[EXTERNAL] PLN20-0541 Comment: 910 Centennial Ave

Subject:—Design Review for 910 Centennial Avenue - -PLN20-0541 (to be considered by the Zoning Administrator on 4-19-21)

Re: PLN20-0541-910 Centennial Avenue

Attachment: Photo of garage at east end of Centennial Avenue

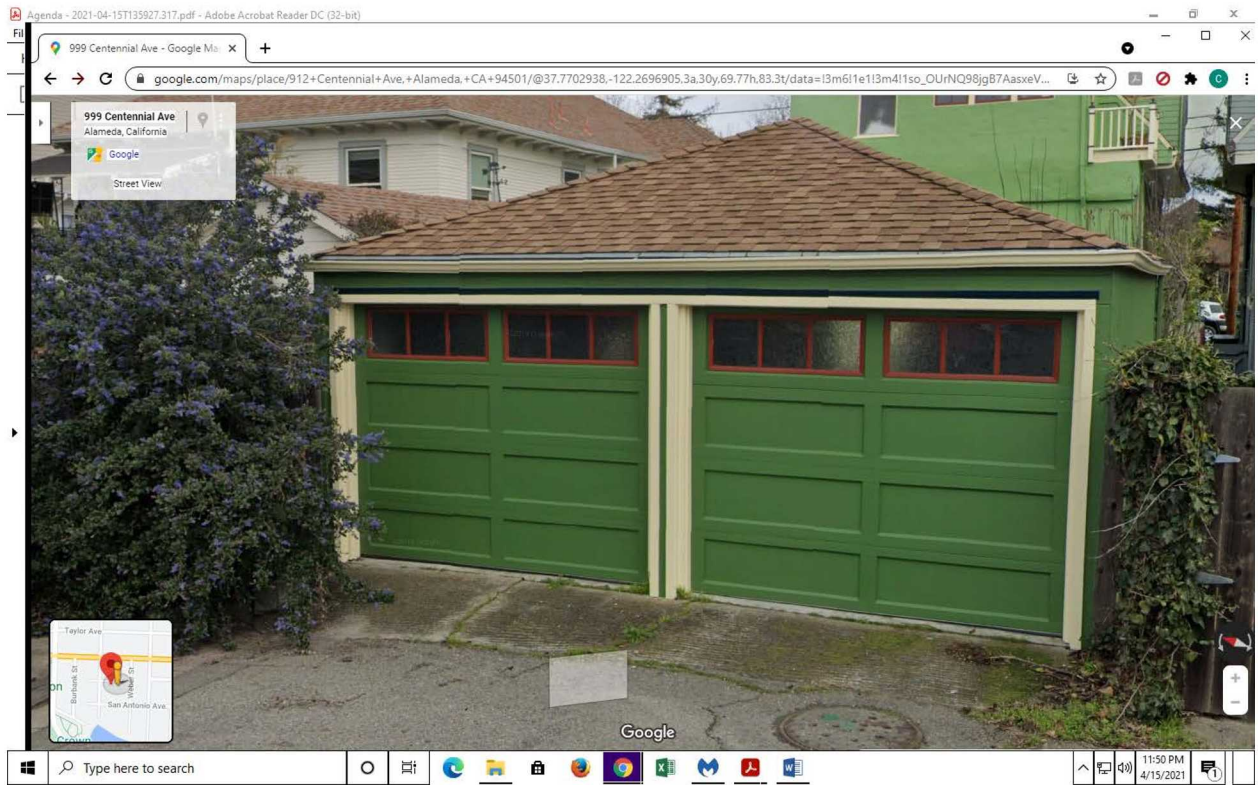
2. **Consider providing “paved tire tracks” instead of the proposed solid paved driveway as per Guide Provision (b) above.**
 3. **Consider providing a more “architectural treatment” of the garage doors.** Although most of the neighboring garage doors do not have what could be considered “architectural treatment” as per Guide Provision (c) above, such treatment should be seriously considered given the visual prominence of the garage. The doors of the nearby garage at the east end of Centennial Avenue are a good model. See attached photo.
